Our ref: 21-011  
DAP ref: DAP/21/02000  
City ref: DA/21/0499

**ADDITIONAL INFORMATION PACKAGE  
PROPOSED CHILD CARE PREMISES  
LOT 642 (104) MULLALOO DRIVE & LOT 643 (20) STANFORD ROAD, KALLAROO**

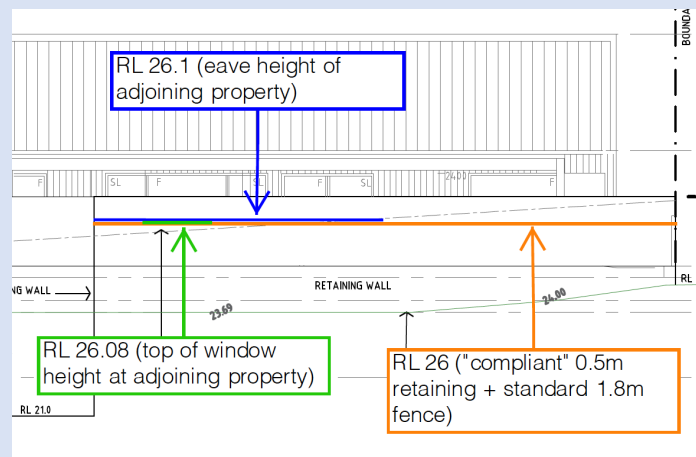
The justification presented in the DA report is reiterated, noting the northern 15m of the eastern boundary provides retaining exceeding 0.5m in height with a 1.8m fence atop. In this regard, it is essential to recognise that based on the existing eave height at the adjoining property (RL 26.1), even a “compliant” scenario of 0.5m retaining + 1.8m solid fence would result in a bulk impact at this would achieve a comparable RL of 26. This is indicated in the below mark-up:
